RESPONSE TO UINTA BASIN COMPOSITION STUDY REVIEW

Utah Division of Air Quality

Figure 2: Separator pressure for gas wells. The mean of each distribution is shown by a blue point, and the median is a black line.

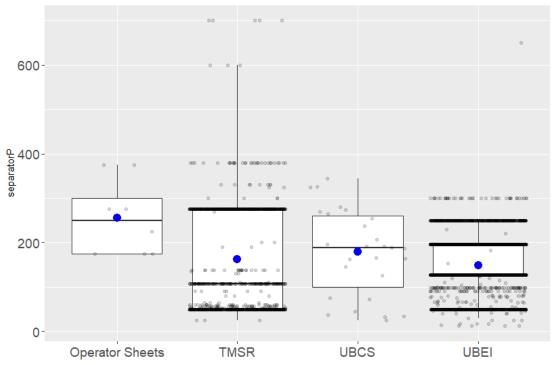
The Review raised concerns about "abnormally high and unexplained separator sample pressures." To evaluate this concern, UDAQ compared the distribution of separator pressures measured in the UBCS with calibrated probes to other available separator pressure data:

Box and whisker plots below show the separator pressure and temperature ranges from these data sources. The mean of each distribution is shown by a red point, and the median is a black line. Markers on the box and whisker plots show the data values which compose the distribution. The Review claims that separator pressures recorded in the UBCS are "unusually high," but the figures below show that the recorded pressures are within ranges reported by operators to other regulatory data sources.

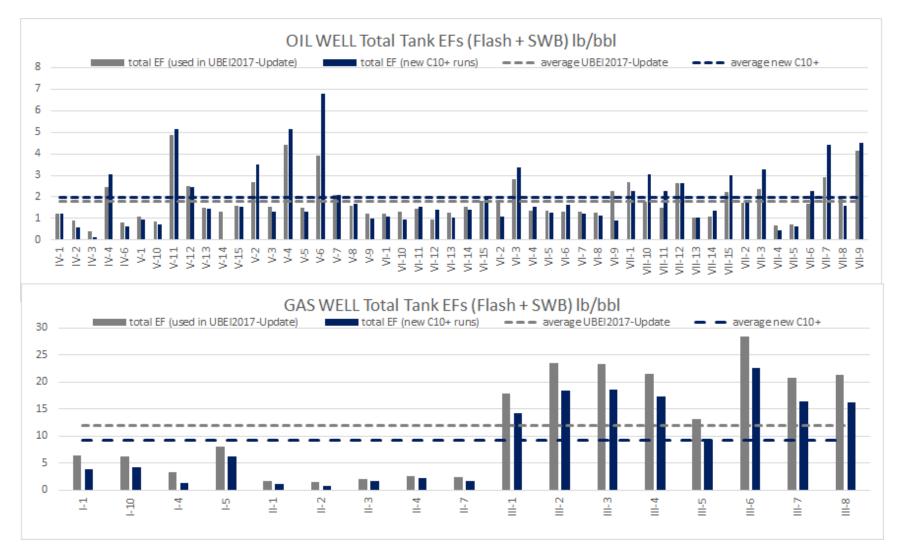
The Review claims that UDAQ failed to leverage ProMax's ability to exactly model decanes plus (C10+) instead of modelling C10+ as C10. UDAQ consulted with ProMax to understand this claim and reran ProMax to utilize the model's more refined C10+. The figures below show UDAQ's previous ProMax simulated tank emission factors (lb/bbl) including flash and AP-42 working and breathing emissions compared to updated ProMax simulations including the C10+ consideration. Note that, in addition to the C10+ adjustment, UDAQ also updated the ProMax simulation to emulate AST's process simulation modeling and Ramboll's recommendation for ambient tanks by *not* forcing the flashing temperature to ambient temperatures and allowing the EOS to calculate the flash temperature at gas well sites. This can be observed in the significant increase in emission rates from gas wells associated with company III.

A slight increase in emission factors is observed for most oil wells using the correct C10+ characterization. A decrease is observed in the average emission factor for gas wells. The UBEI2017-Update white paper shows an increase (from UBEI2017) in VOCs from condensate tanks of +3658 TPY VOCs. With adjustments to the flashing temperature *and* C10+ characterization, total additional VOCs from condensate tanks is +2188 TPY VOCs. For oil wells, the C10+ adjustment result in an increase of +1701 TPY VOCs (compared to +1411 TPY in the white paper.) These adjustments to VOC totals from tanks will be reflected in UBEI2017-Update in an upcoming revised white paper version.
